1174 Fort – Long Term Care Pharmacy

Site Plan Review

Applicant	Zeinab Dagher
Project	Pharmacy (Long Term Care)
Address	1174 Fort Street, Lincoln Park, MI 48146
Date	December 11, 2019
Request	Site Plan Review
Recommendation	Table

Drawing Title:
 EXISTING SITE PLAN

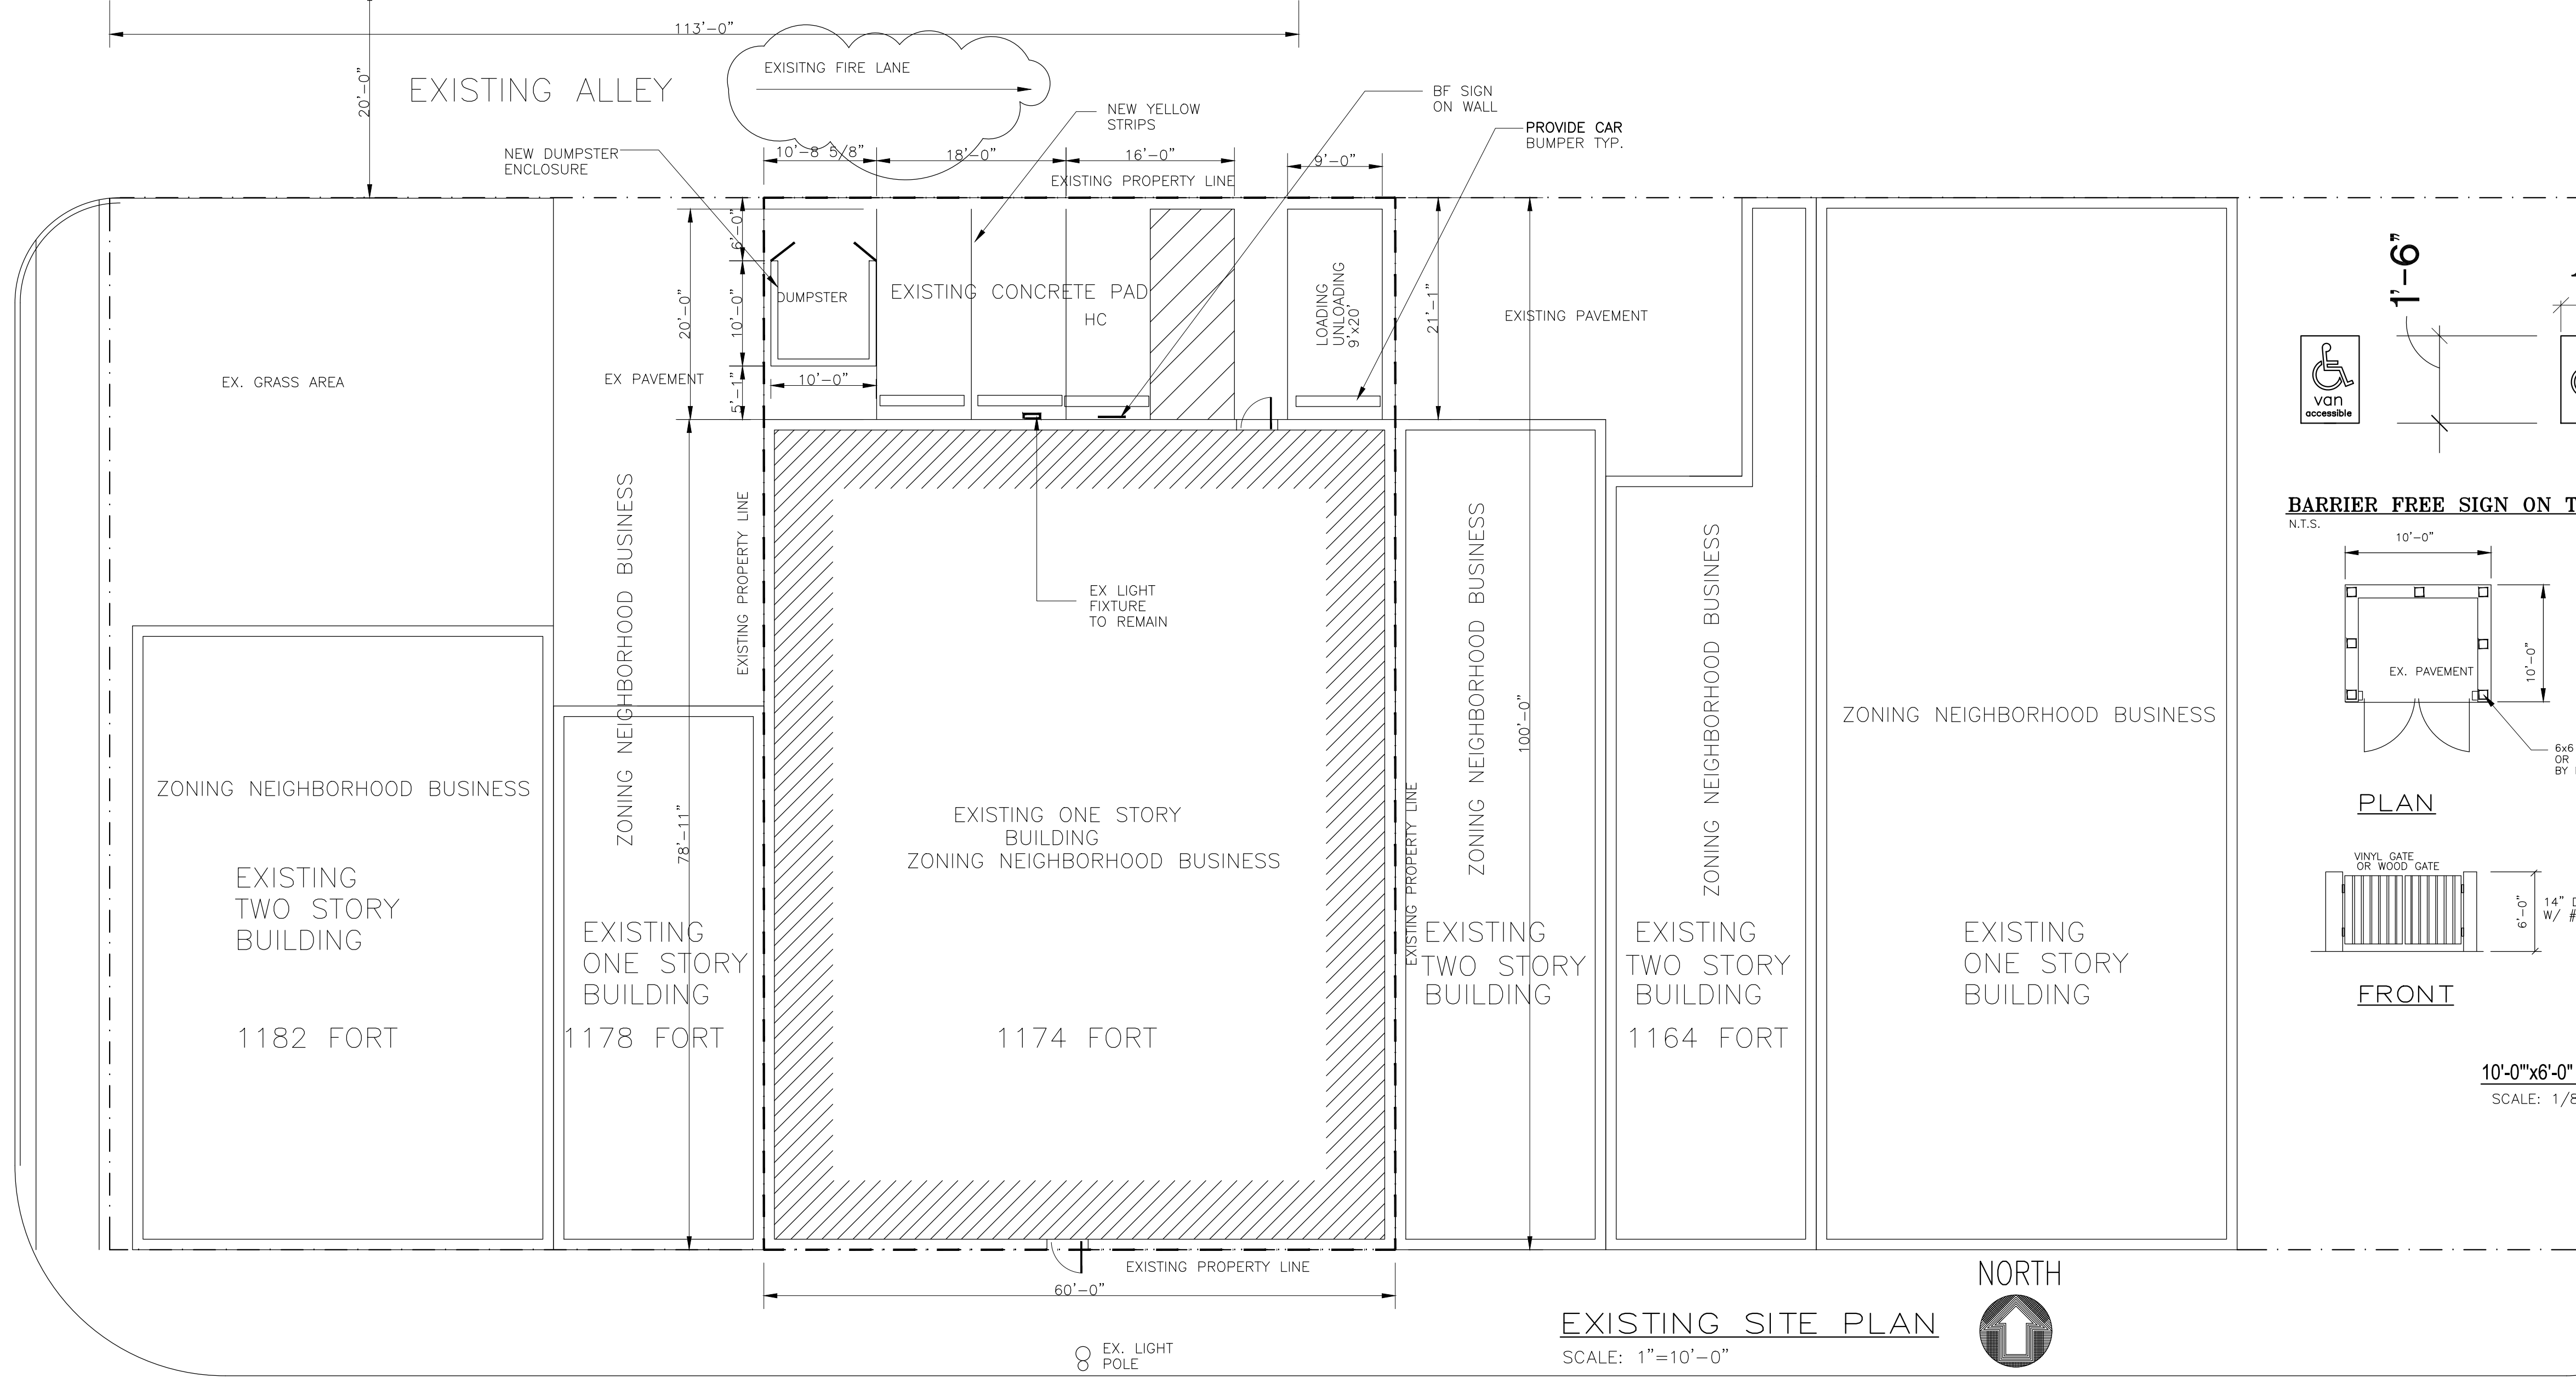
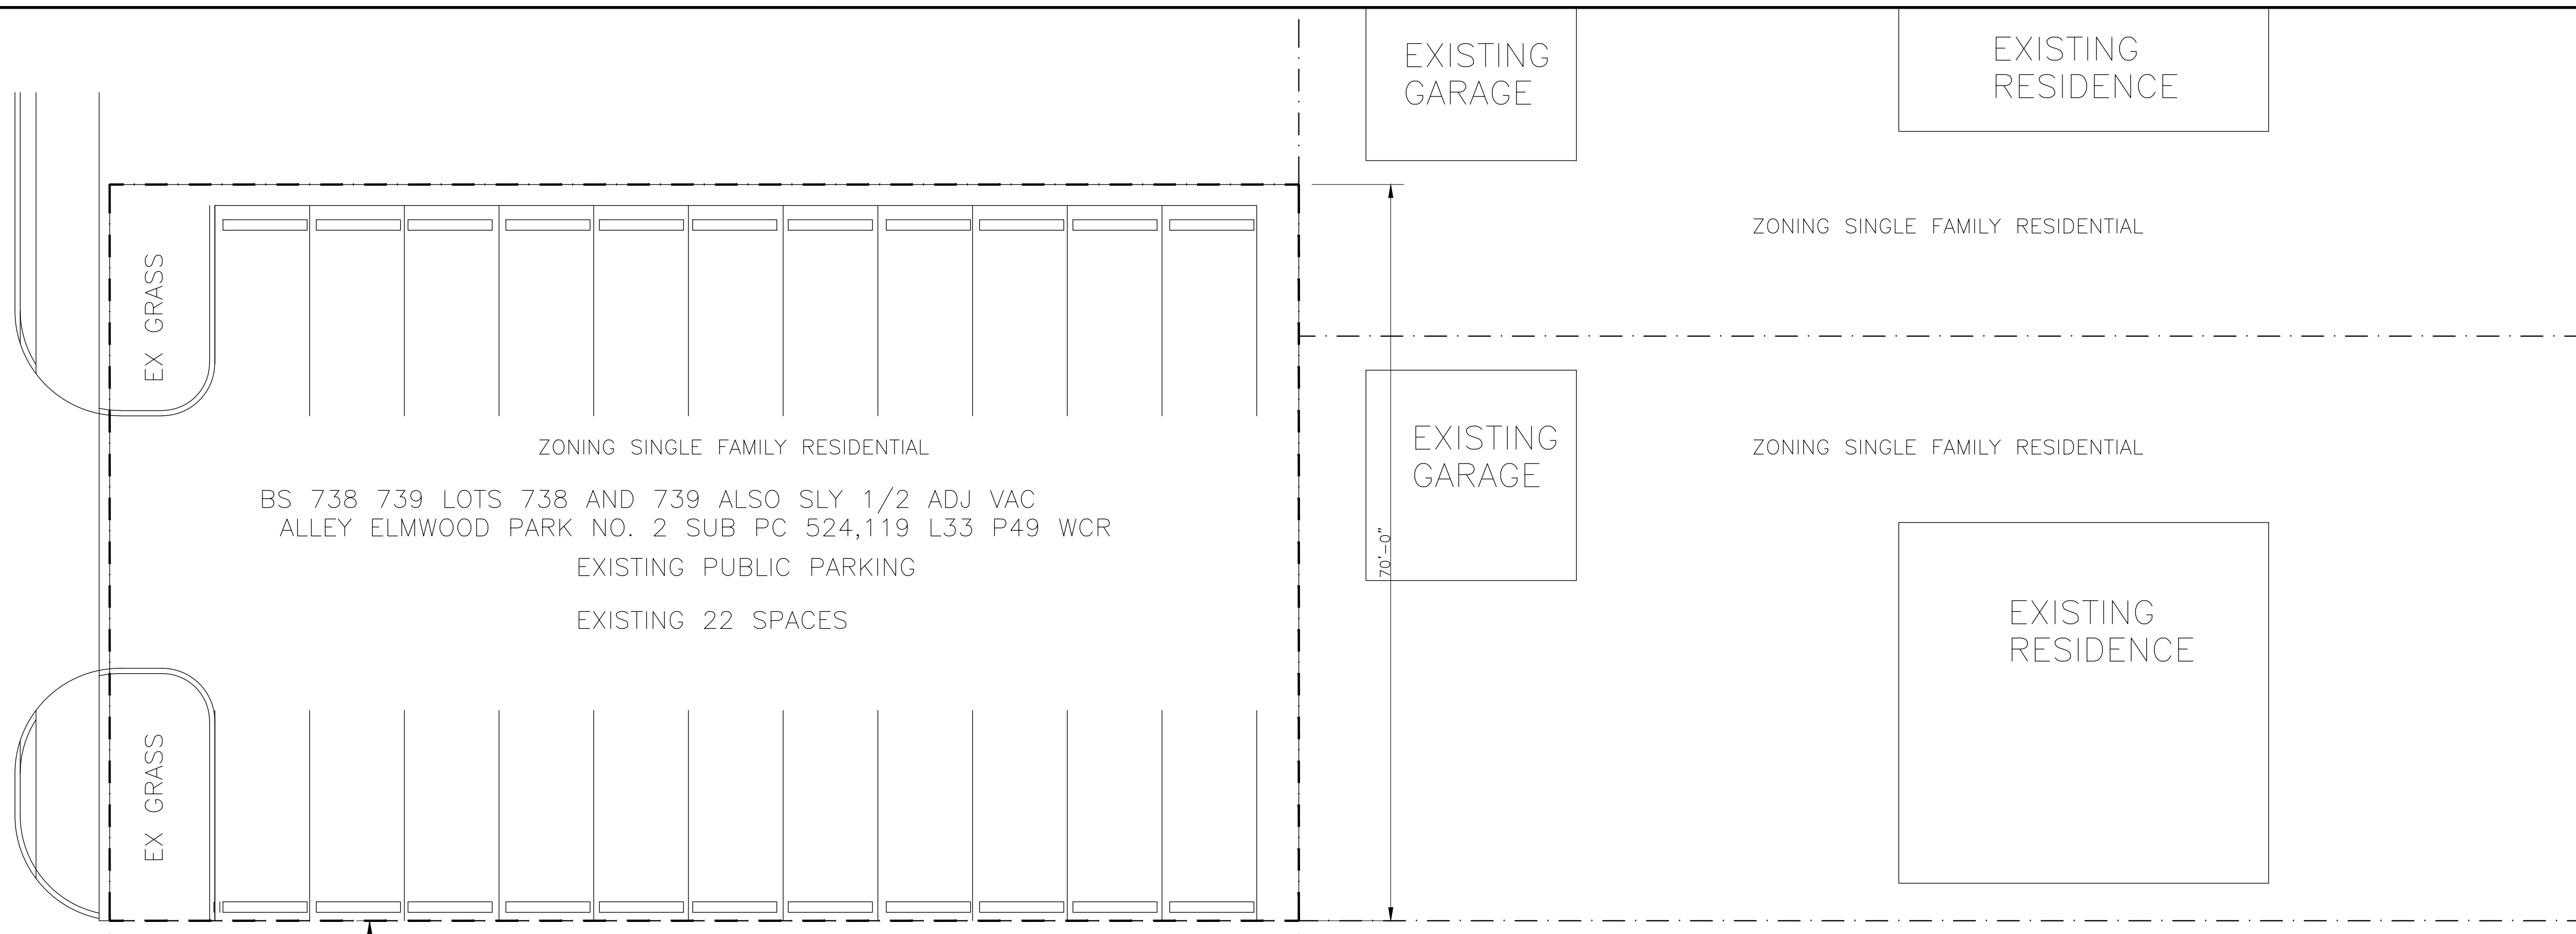
The Existing Site Plan (SP-1) indicates provision of existing fire lane within the public alley between the rear property line and the existing public parking property line.
